# Access Compliance Report

## Public Rights-of-Way

Intersection ID: 52452	Main Street: PAT_GARRETT_ST	Cross Street: BENDING_BIRCH_PL	Location: SE
ADA ID: 451435787ACF	Ramp Type: Directional1	Initial Pass/Fail: Fail	Overall Compliance: No
Severity Score: 37.5			
Codes/Mitigation Info/Possible Solution		Field Measurements/Component Compliance

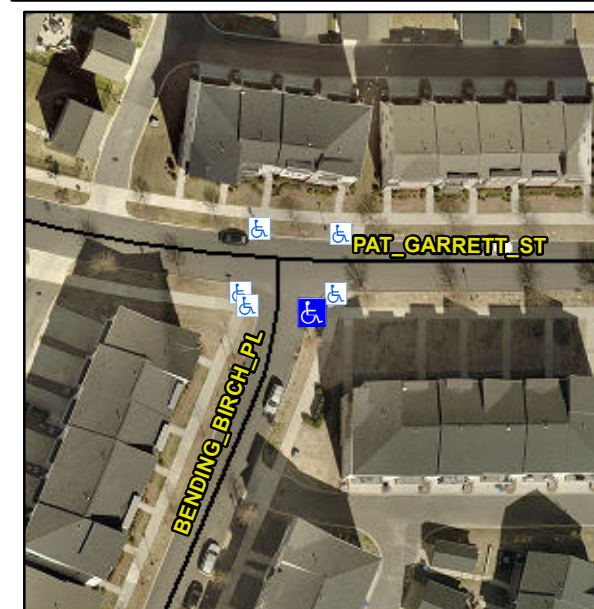
**Remove & Replace Entire Ramp.**

**R304.2.2, R304.5.3**

Compliance	Description	Data	Compliance	Description	Data
N/A	Ramp Length (in)	93.0	N/A	Grade Break?	N/A
Yes	Ramp Width (in)	66.0	N/A	Grade Break Slope (%)	0.0
No	Ramp Slope (%)	12.9	N/A	Grade Break XSlope (%)	0.0
No	Ramp XSlope (%)	6.9			
N/A	Flare Type LT	N/A	N/A	Flare Type RT	N/A
N/A	Flare Slope LT (%)	N/A	N/A	Flare Slope RT (%)	0.0
N/A	Flare Traversable LT?	N/A	N/A	Flare Traversable RT?	N/A
N/A	Landing Length (in)	0.0	N/A	DWS Provided?	N/A
N/A	Landing Width (in)	0.0	N/A	DWS Contrast?	N/A
N/A	Landing Slope (%)	0.0	N/A	DWS Length (in)	N/A
N/A	Landing X Slope (%)	0.0	N/A	DWS Full Width?	N/A
N/A	Landing Curb? (Y/N)	N/A	N/A	DWS Offset LT (in)	N/A
N/A	Shared Landing?	N/A	N/A	DWS Offset RT (in)	N/A
N/A	Gutter Ponding?	0.0	N/A	Gutter Slope (%)	N/A
N/A	Gutter Lip Ht (in)	0.0	N/A	Gutter X Slope (%)	N/A
N/A	Painted X Walk1?	No		Road Slope (%)	1.0
	X Walk 1 Direction	To W		Road X Slope (%)	2.6
	X Walk 1 Width (in)	N/A		Clear Space?	N/A
